4.I. Staff Review - 777 Stevens Avenue - Park Danforth

**LEGAL ADVERTISEMENT
PORTLAND PLANNING BOARD MEETING**

**AGENDA
PORTLAND PLANNING BOARD**

Planning and Urban Development Department

FORE STREET SECTION WITH B6 HEIGHT OVERLAY

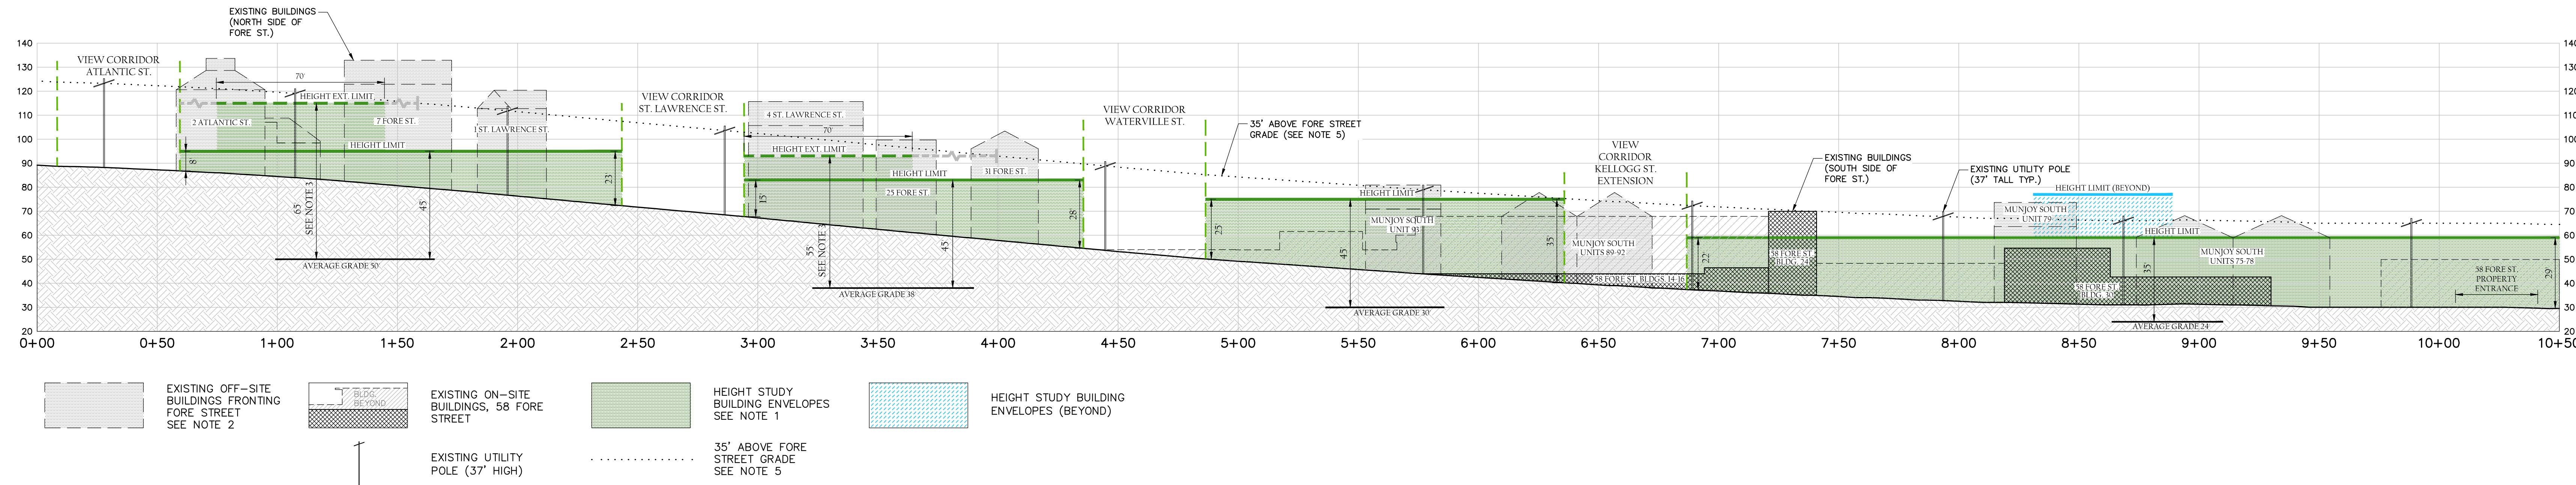
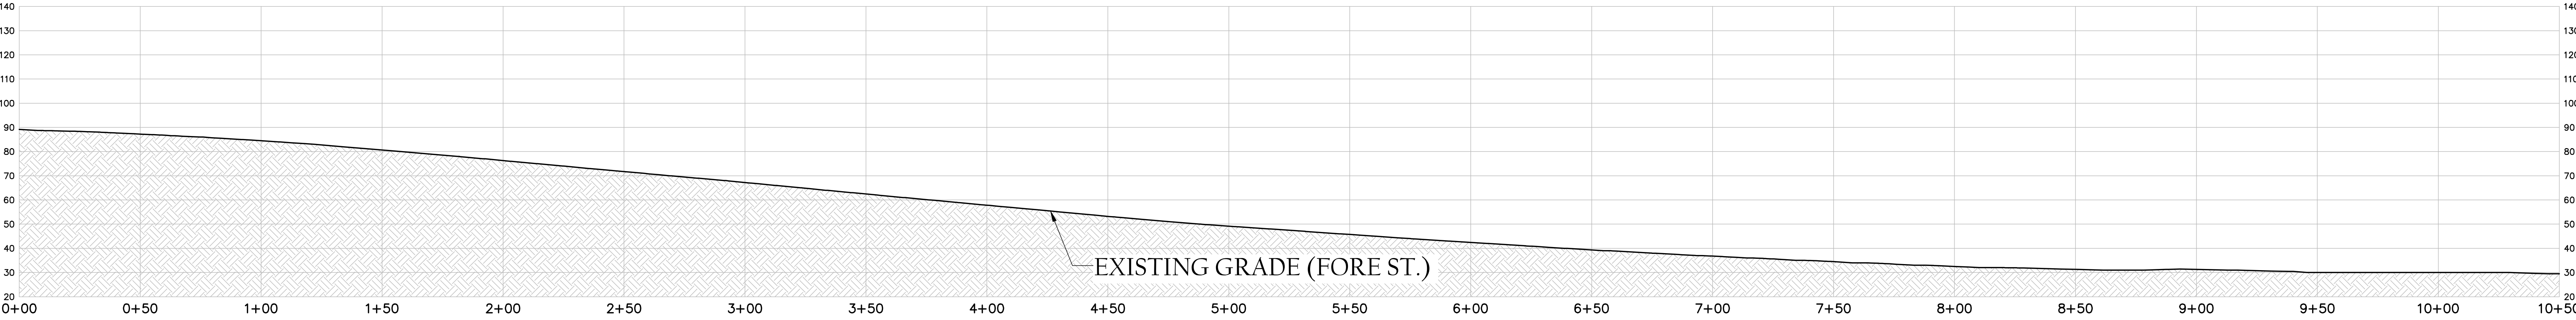
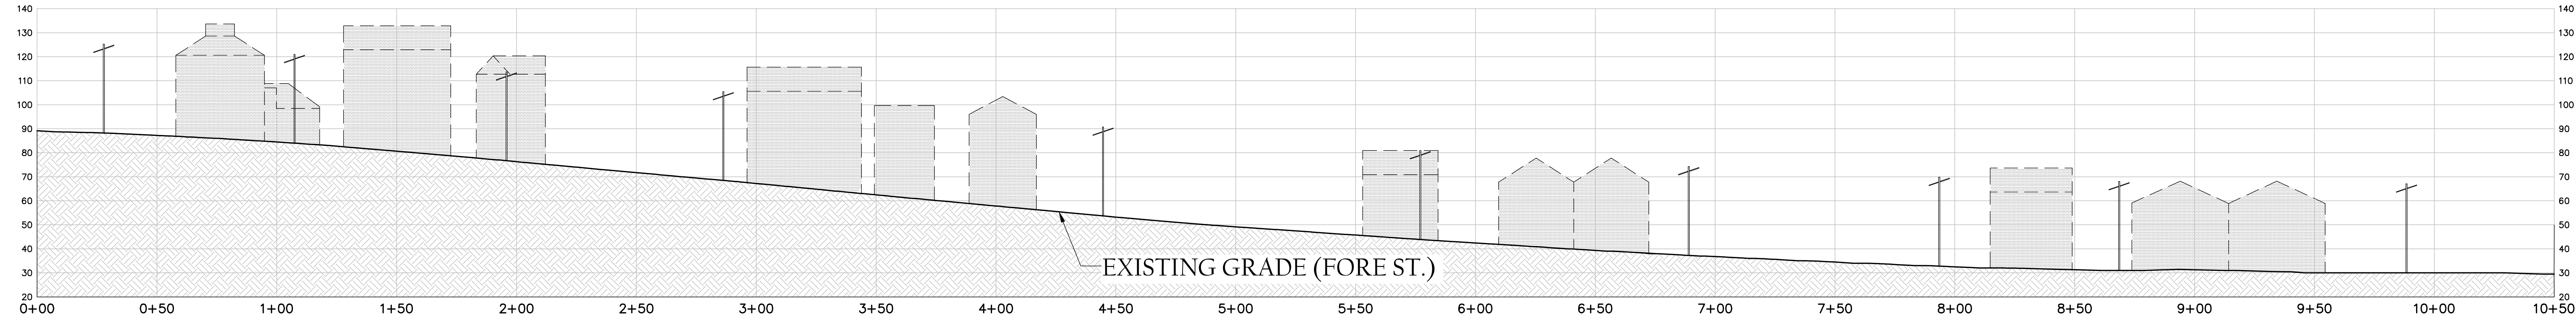
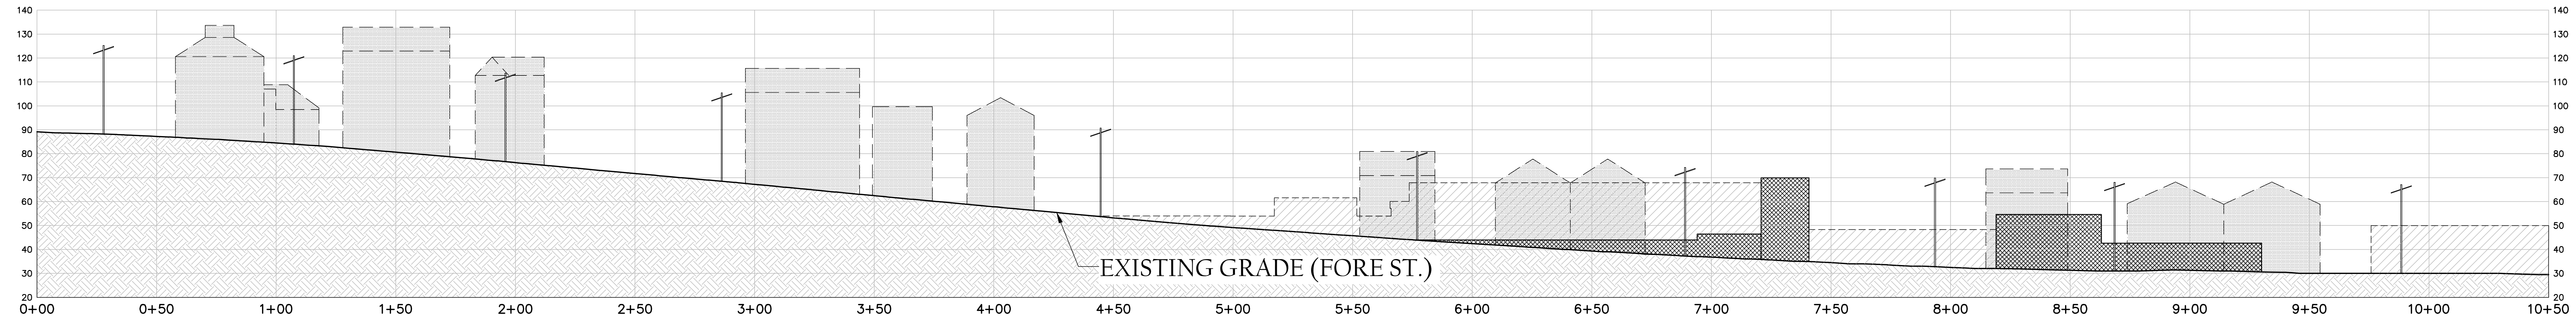
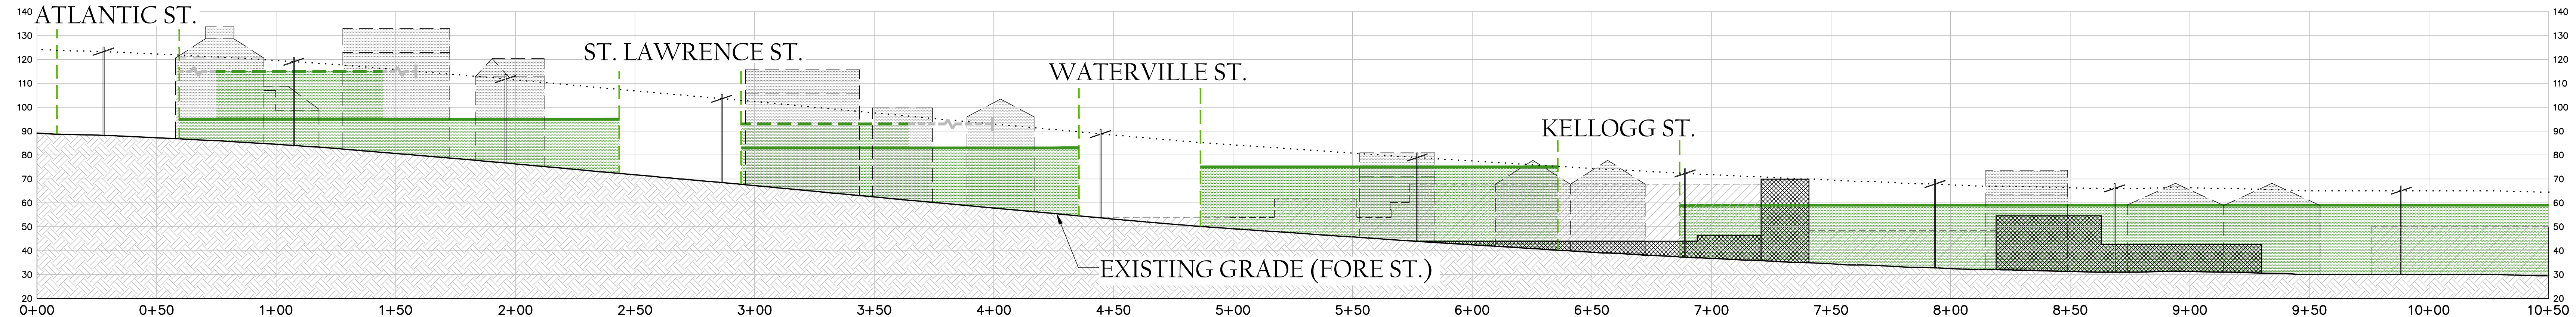
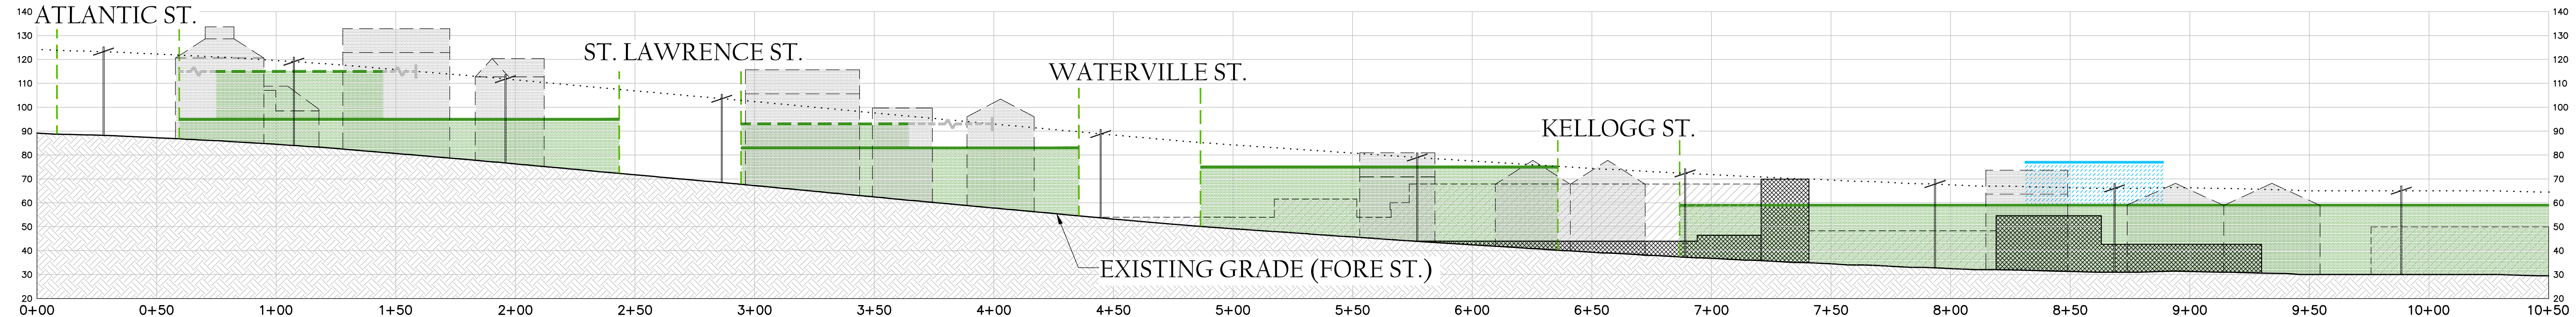
At the November 18th meeting the Board requested additional visuals to better understand the height implications of the project both from Fore Street looking south, and from the southern portion of the property looking towards Fore Street. An excerpt of the response to that request is included in Figure 6 and the full visuals are included as Attachment D. The section below layers existing buildings on Fore Street (north side of street), maximum building envelopes under the B-6 Height Overlay, buildings at 58 Fore Street that are visible at Fore Street, a dashed line marking the 35 foot height maximum proposed at Fore Street, and the heights and location of existing utility poles. View corridors are depicted, as well.

L3.0

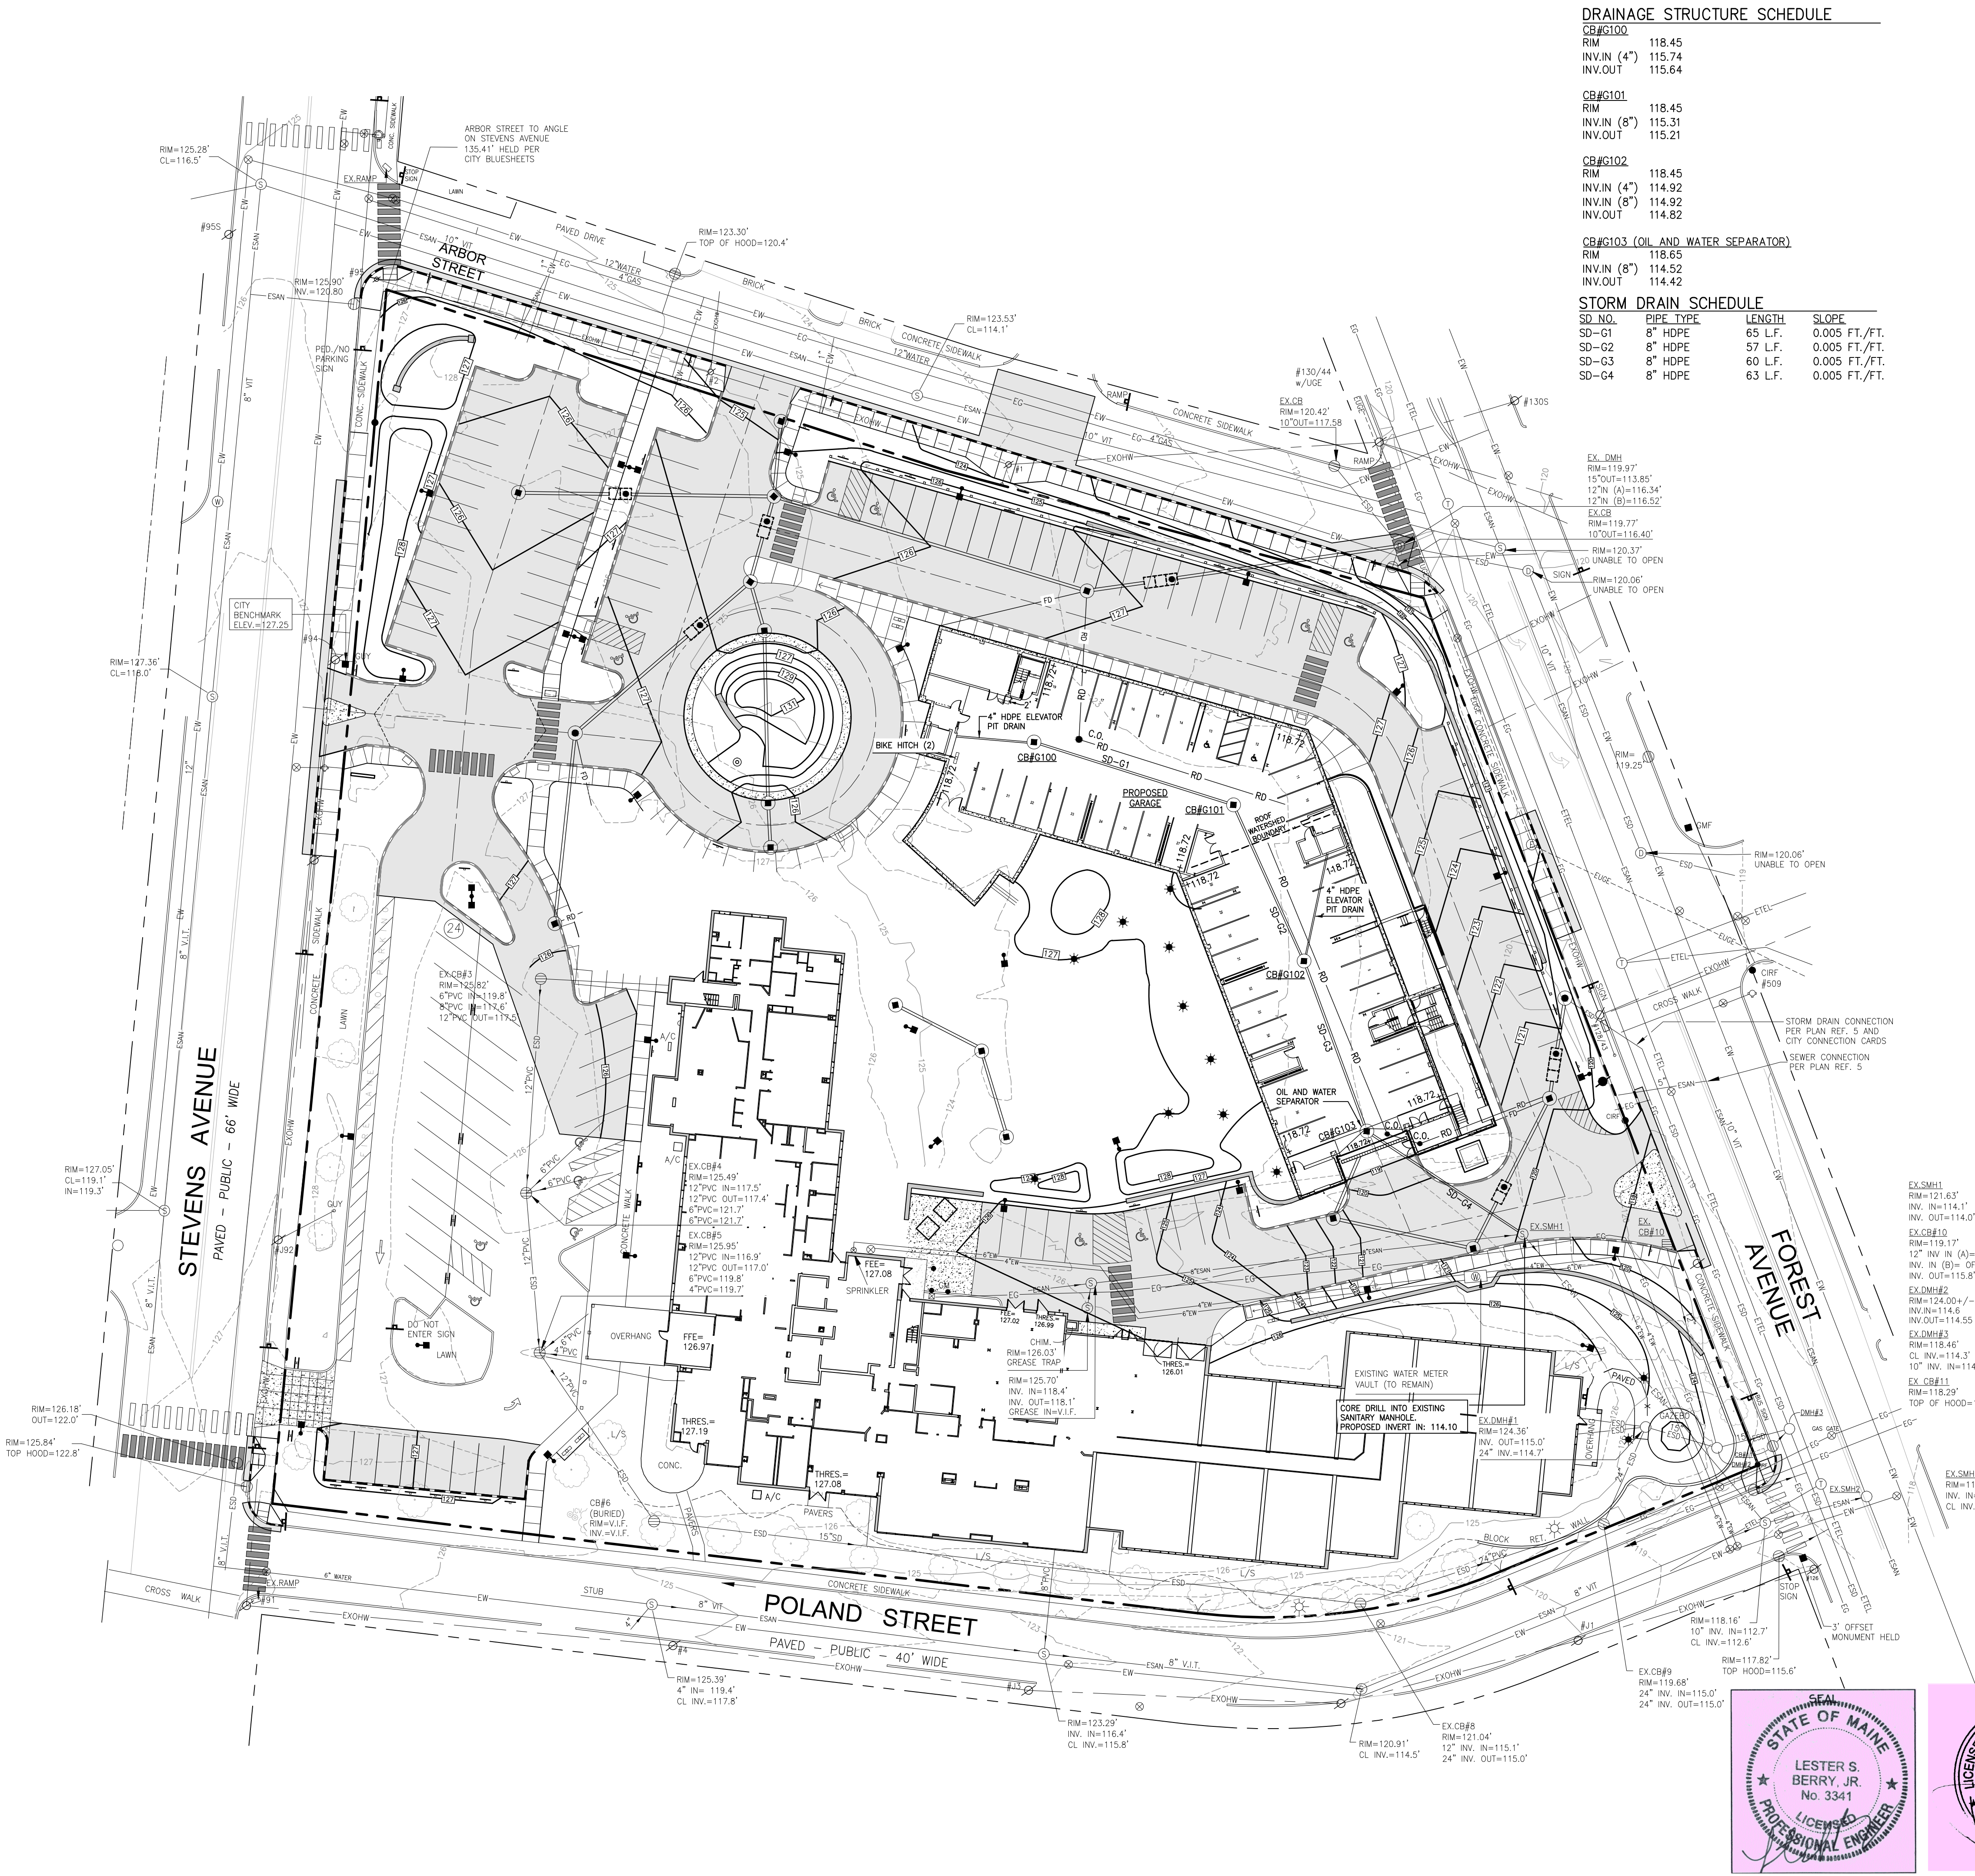
1. All proposed Storm water drainage shall be directed to Forest Ave and Read Street unless demonstrated not feasible. This has not been done. The drainage plan L4.0 is incomplete and requires a stamp by a Professional Engineer. This plan is unacceptable.

1. All proposed stormwater drainage shall be directed to Forest Ave and Read St unless demonstrated not feasible.
Drawing L4.0 revised 11-25-14 now shows an acceptable drainage plan. Plan is now stamped by a PE.

- **The plan previously submitted Plan Sheet L4.0, dated November 25, 2014, did separate the storm water to direct the majority of new site impervious area, including more than one-half of the new roof area, and a small portion of pre-existing runoff from The Park Danforth is directed to the Forest Ave-Read Street by-pass. Only a small area of the site perimeter access drive, parking garage and the portion of the new roof along the Forest Avenue frontage continues to flow to the Forest Avenue storm drain. Due to grade/invert issues, the entire area could not be directed to the Forest Ave-Read Street by-pass.**

Plan Sheet L4.0 was stamped by Les Berry PE
